CITY OF ALBUQUERQUE

**Re: Renovation Building Shell
10921 Central Ave. NE
30-Day Temporary Certificate of Occupancy
Transportation Development Final Inspection**
Architect's Stamp dated 01-26-24 (L21-D030)
Certification dated 02-14-25

TRAFFIC CERTIFICATION

SITE PLAN SHOWING NEW PARKING

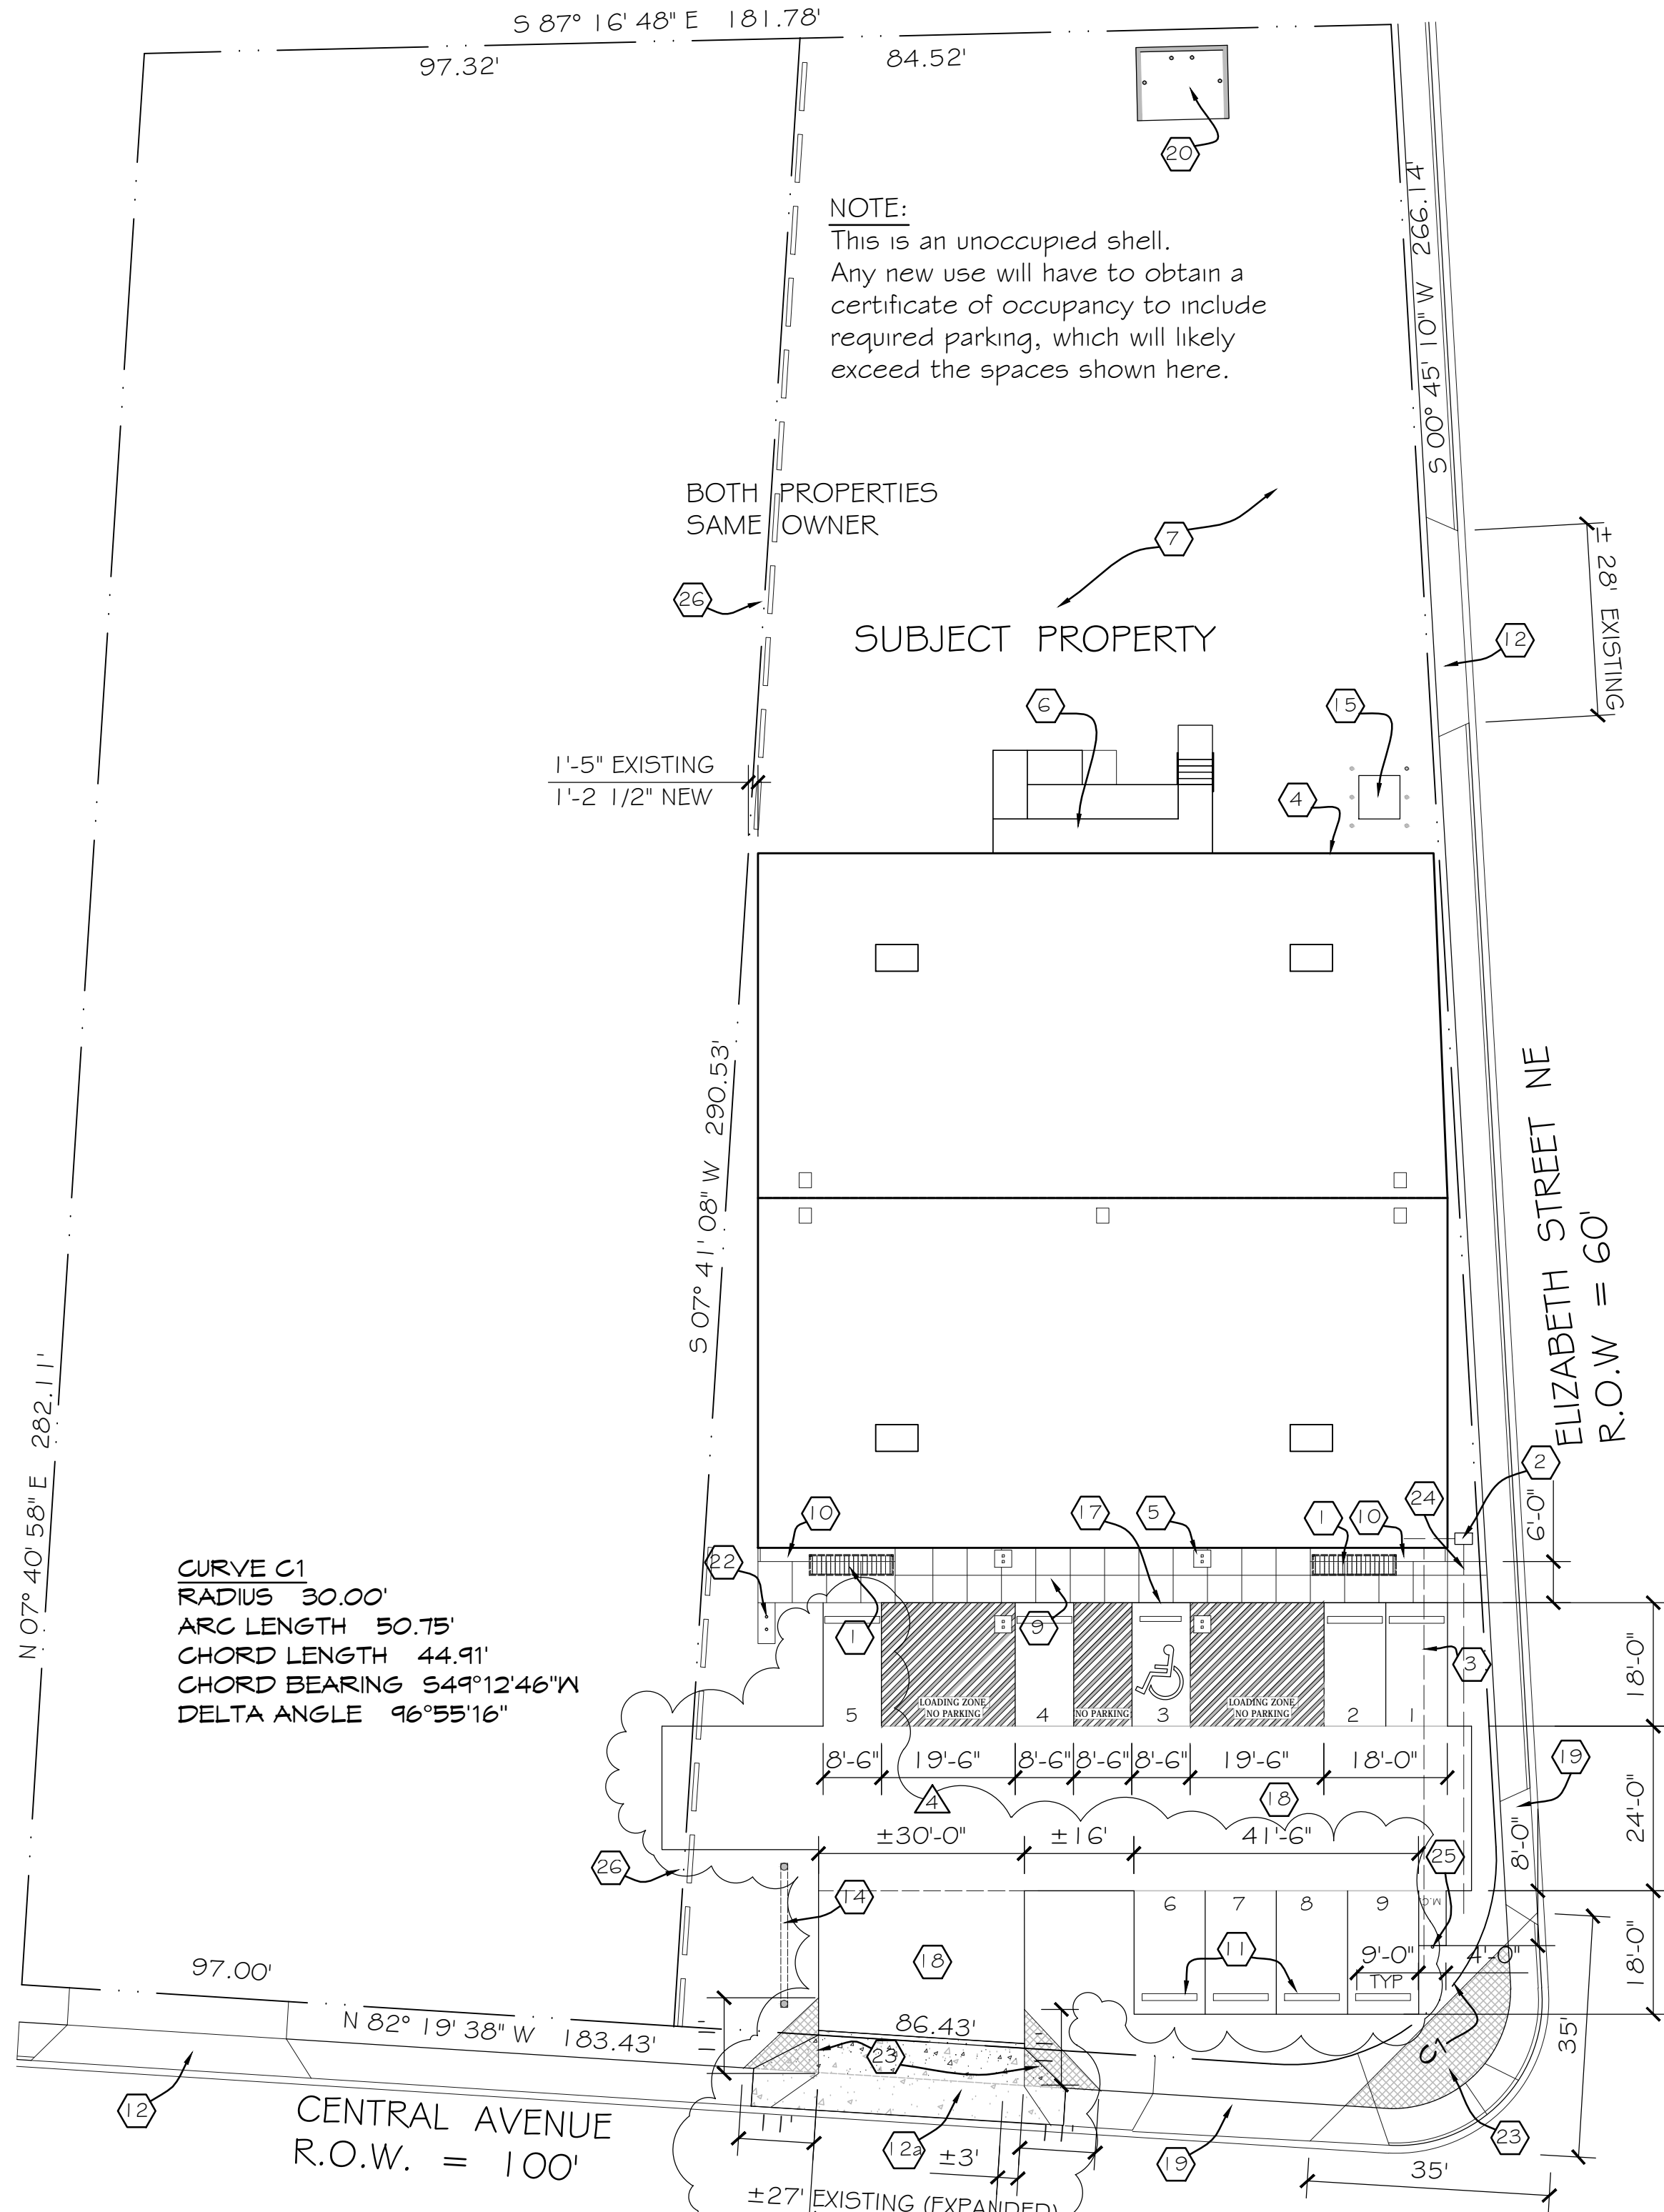
- Per approved plan keynote 12: the site access off Elizabeth St. must be ADA compliance.
- Anchor down Bike Rack.

11. CONCRETE PARKING BUMPER EACH SPACE
12. EXISTING CURB CUT AND DRIVE TO REMAIN. MODIFY SIDEWALK RAMP IF SLOPES ARE NOT CORRECT AND ADD TACTILE TRUNCATED DOME WARNINGS PER COA STANDARD DRAWING 2425B (DRIVE AT BACK OF CURB).
